**ADDENDUM NUMBER: ONE**

**ISSUED BY: SEPW Architecture Inc.**  
109 – 3725 Pasqua St., Regina, SK. S4S 6W8  
PH. (306) 569-2255

**PROJECT: INPUT HOUSING, MITCHINSON & WAKELING  
HARBOUR LANDING, REGINA, SK.**

PROJECT NO. 10/2016		DRAWING NO.  <b>A0.1R1</b>
DATE 2019-02-20	SCALE AS NOTED	
DRAWN GP	CHECKED DE

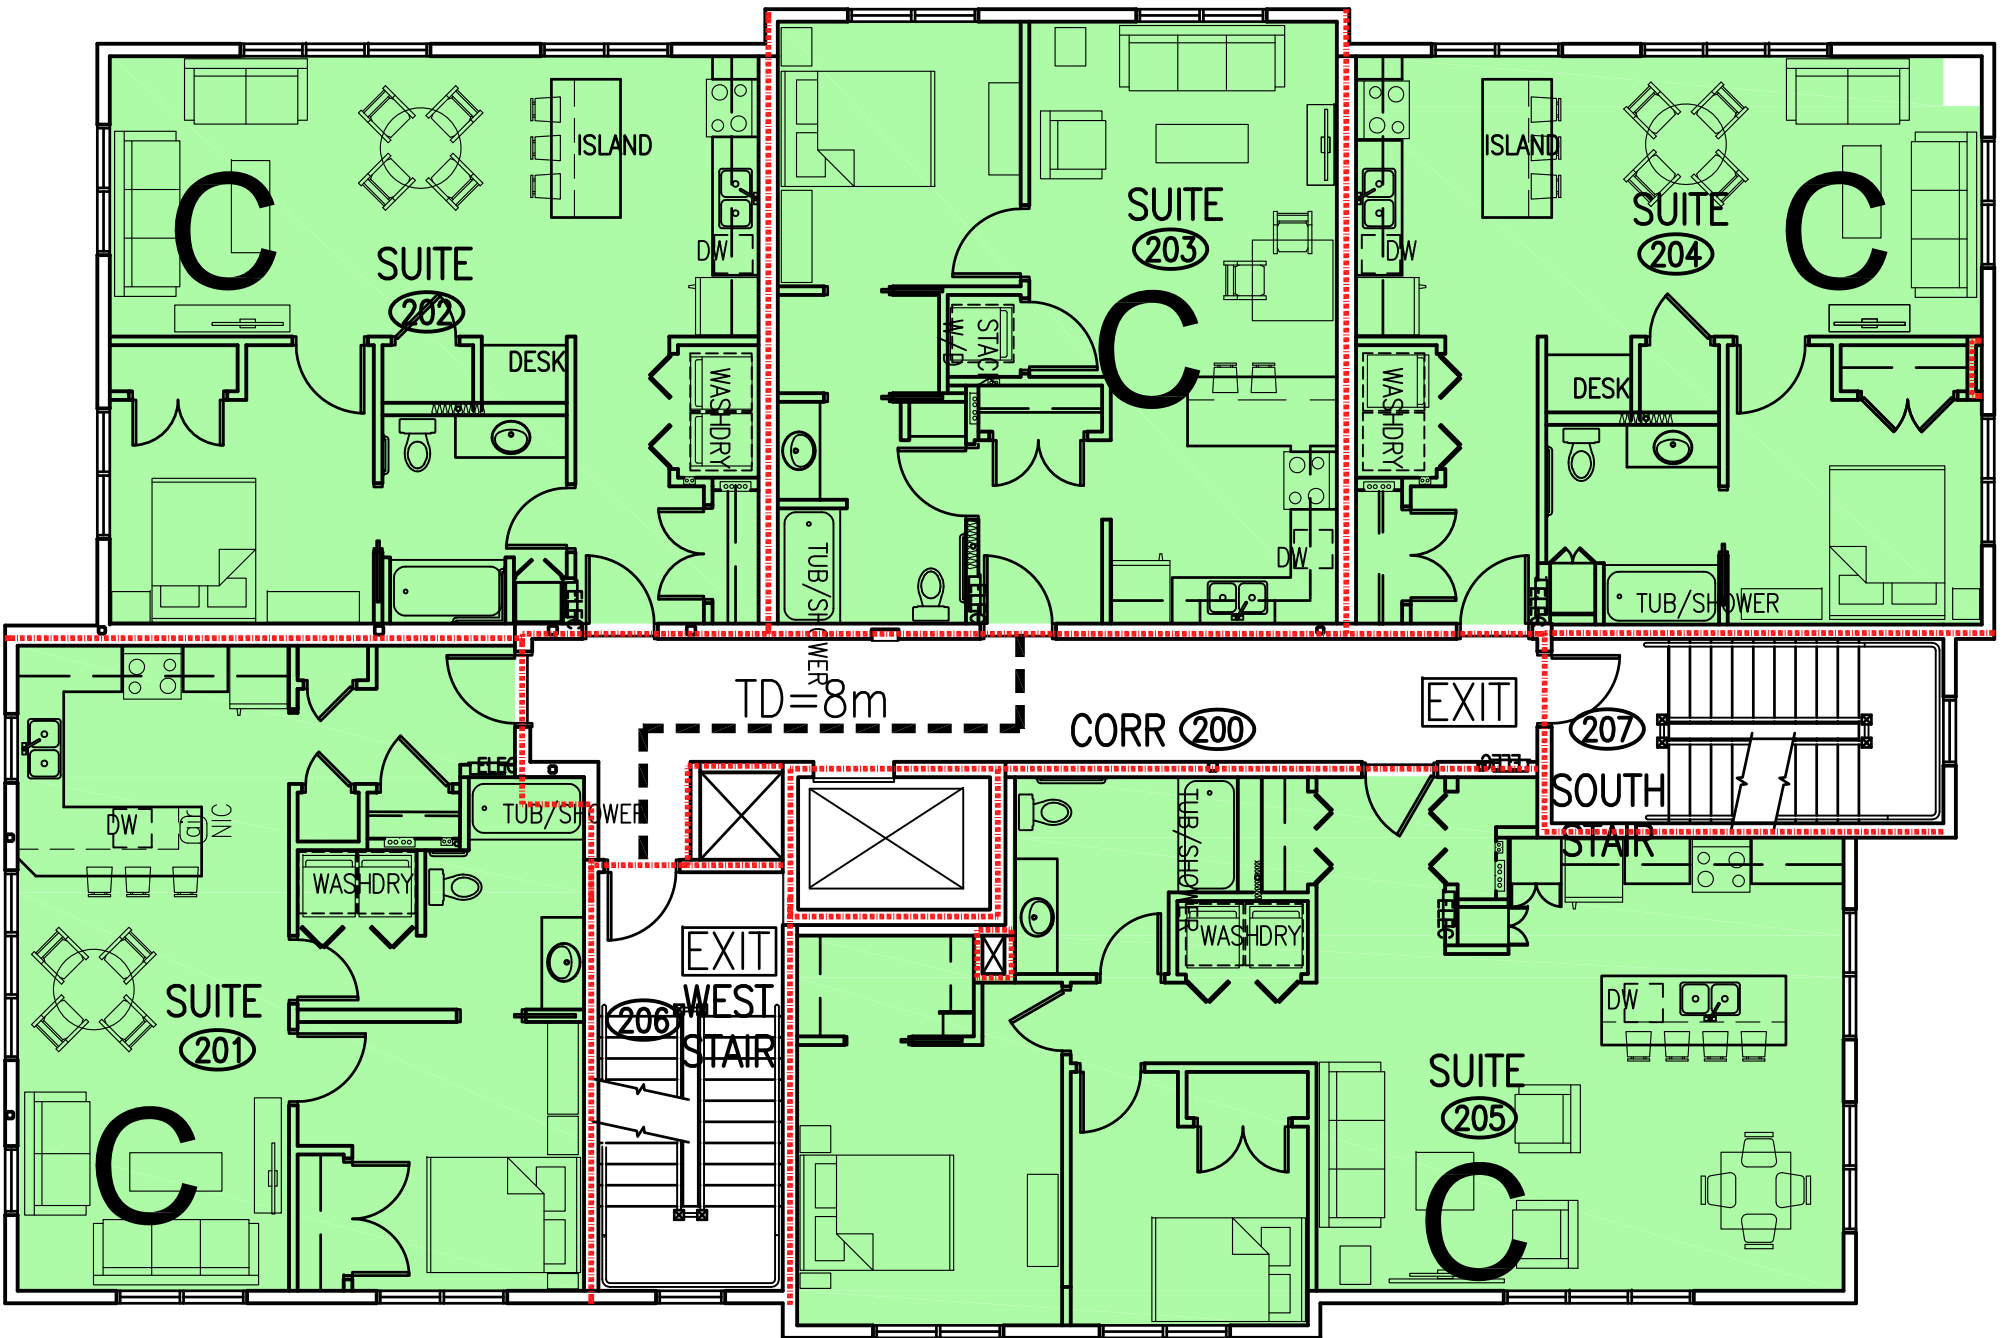
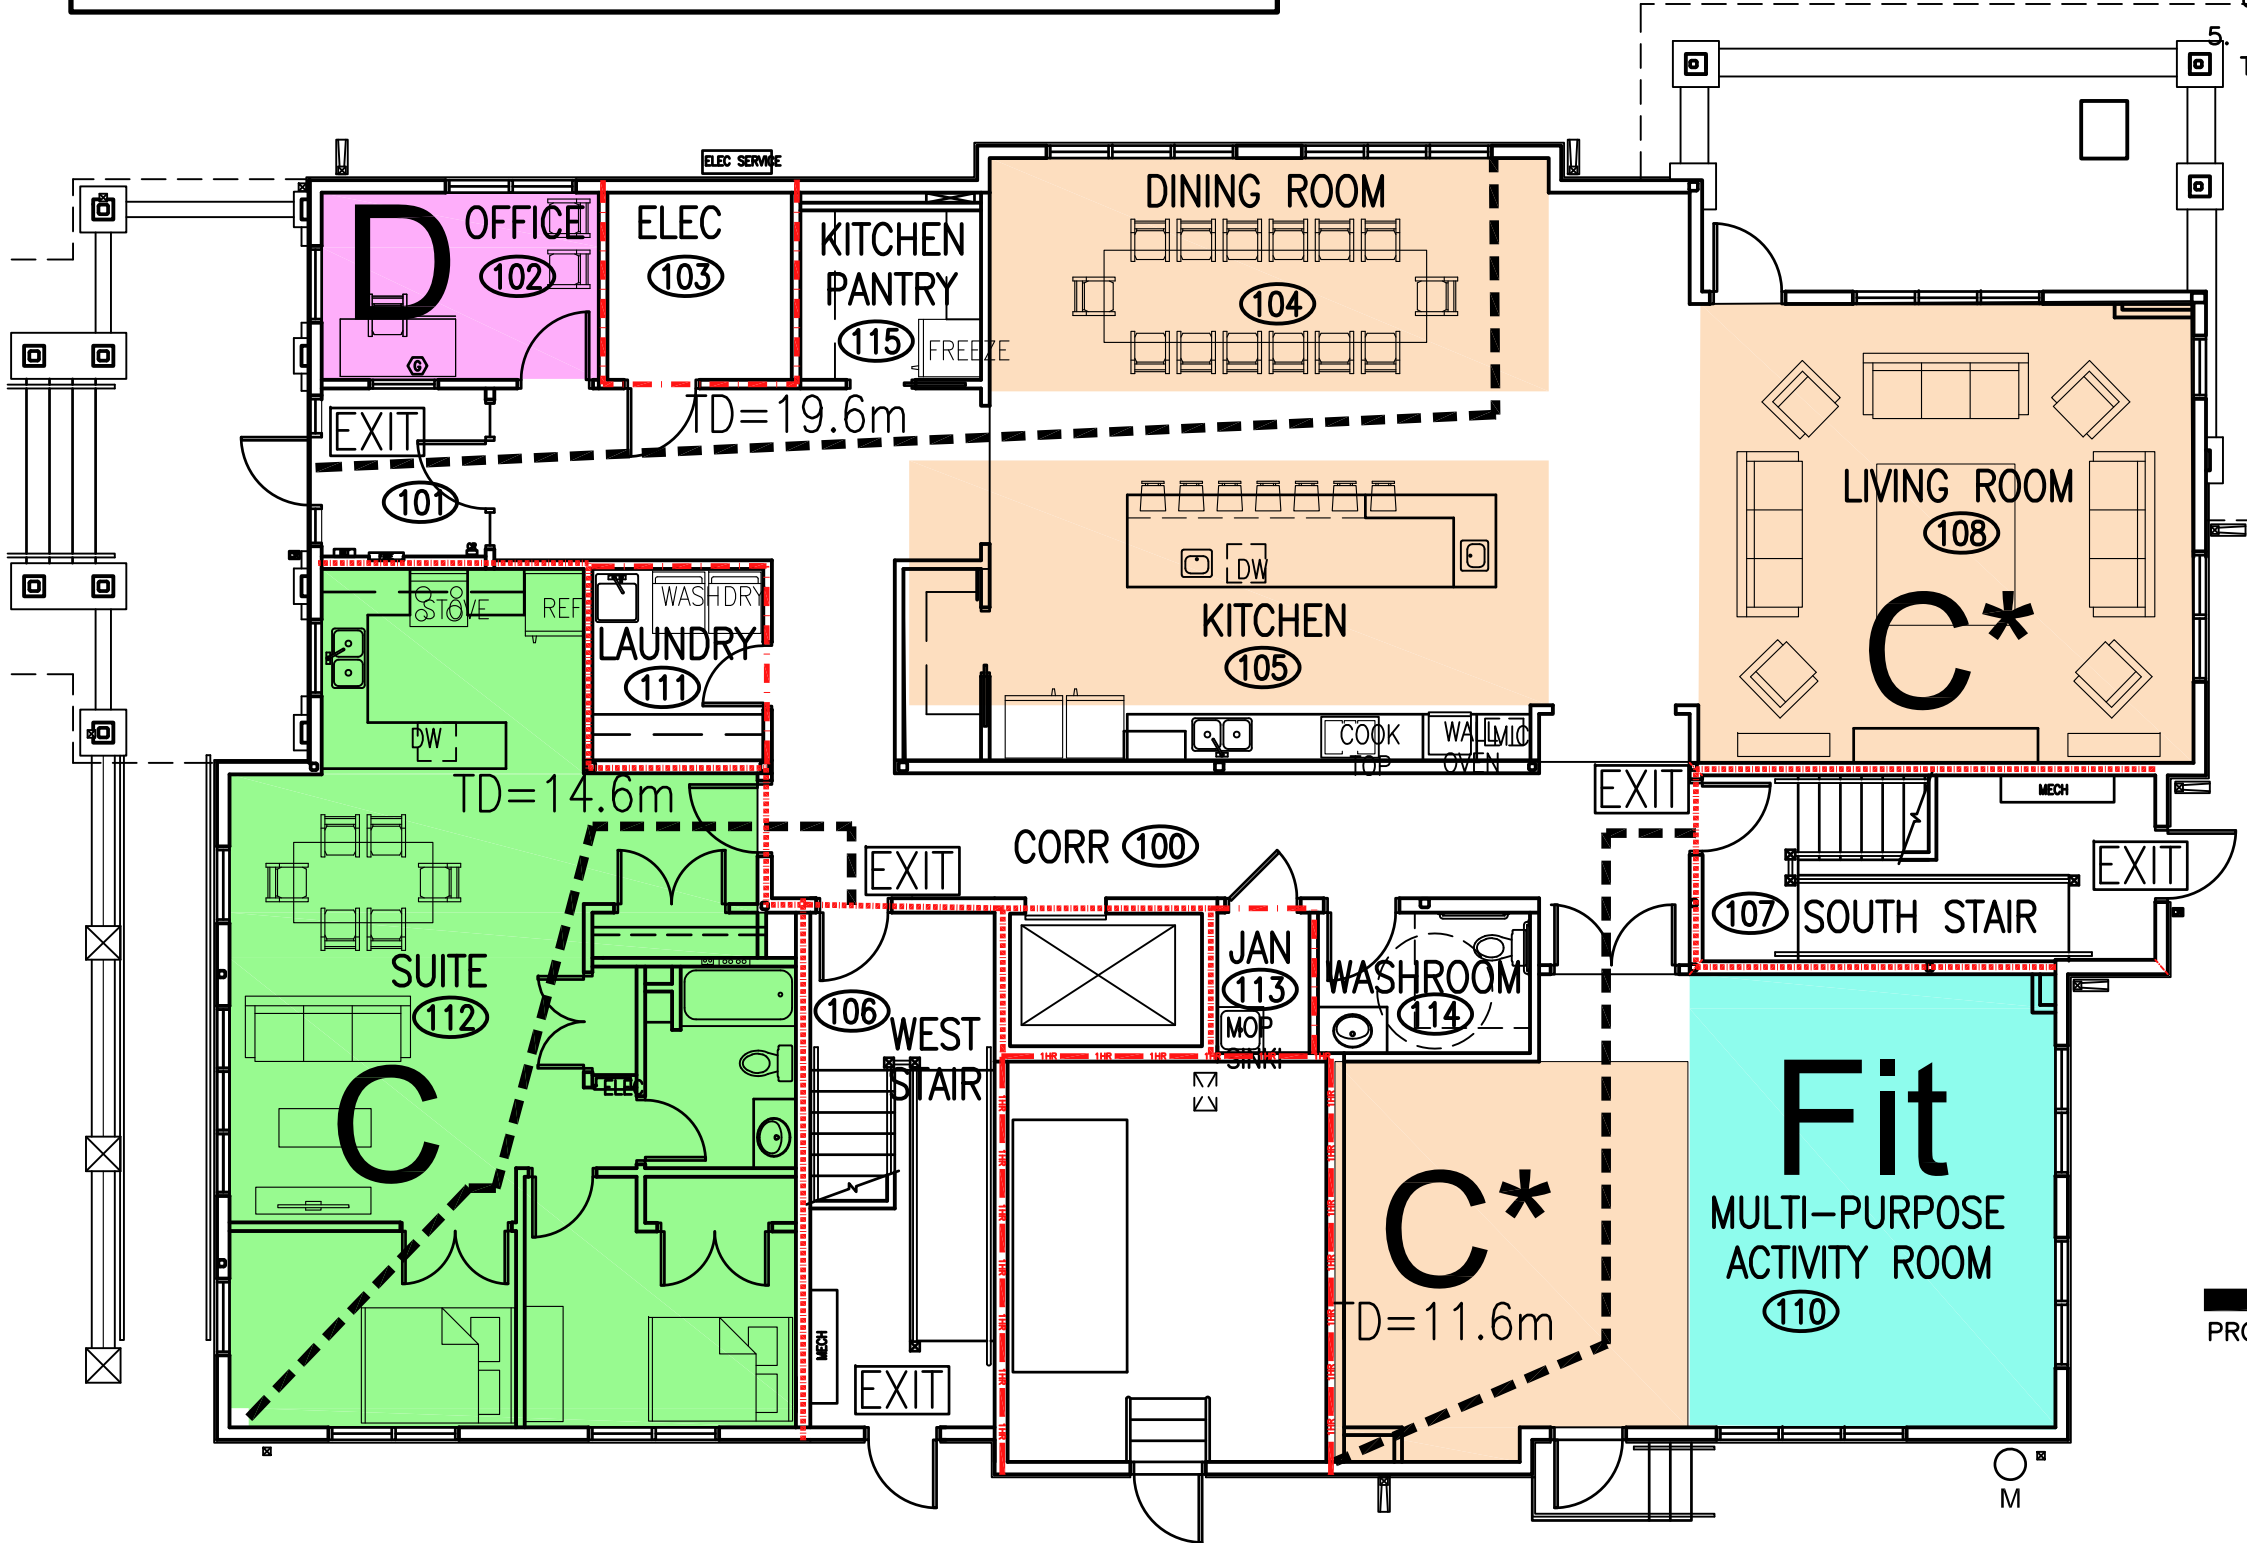
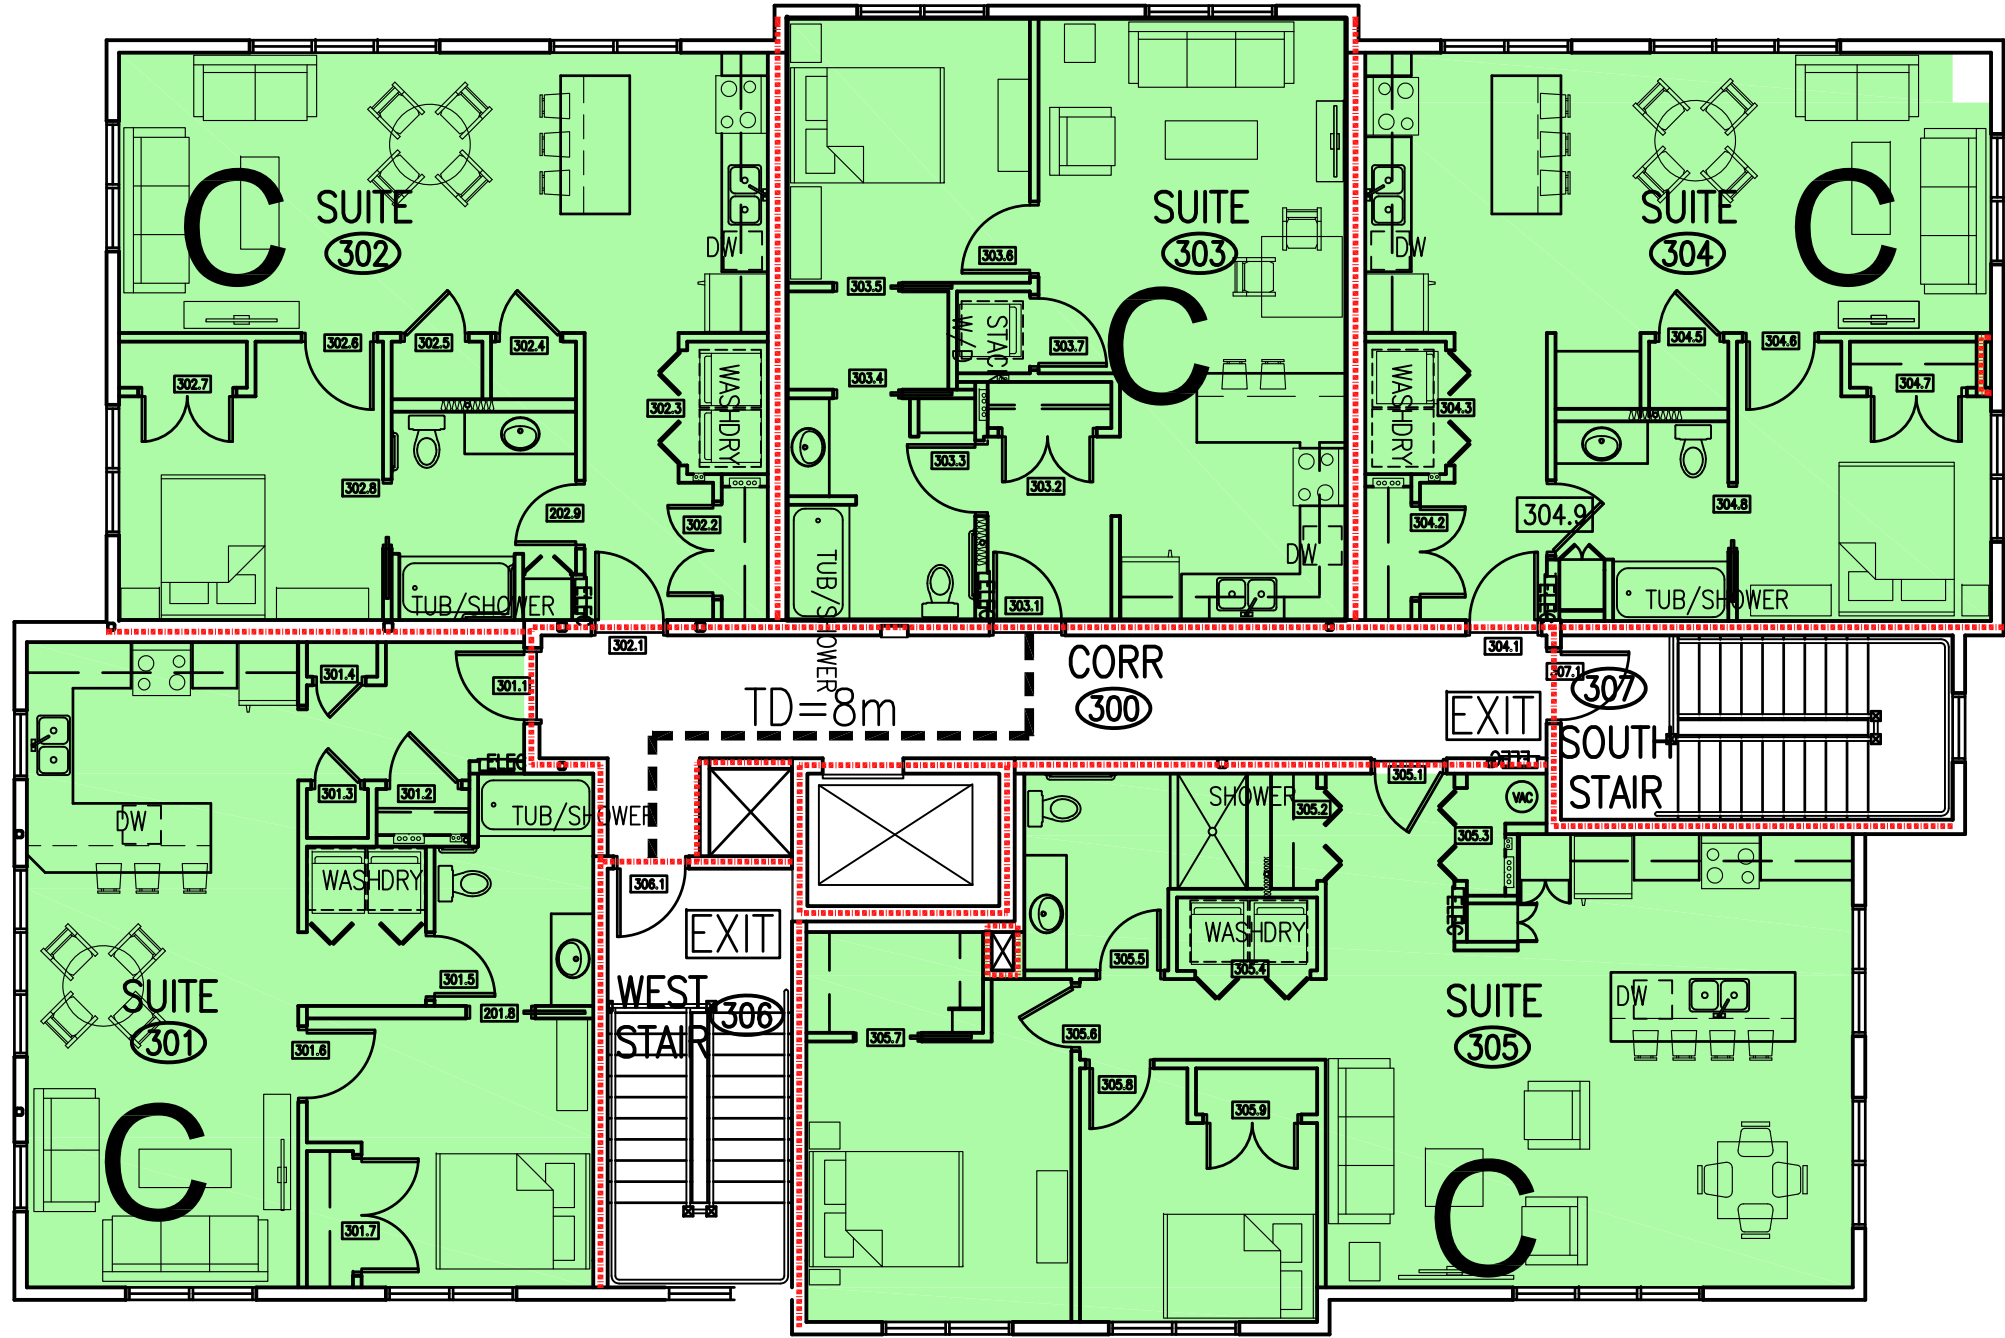
REPLACE drawing with A0.1R1. Revised plan 2/A0.1R1 adds 45 min fire-resistant rating to north wall of west stair on the main floor.
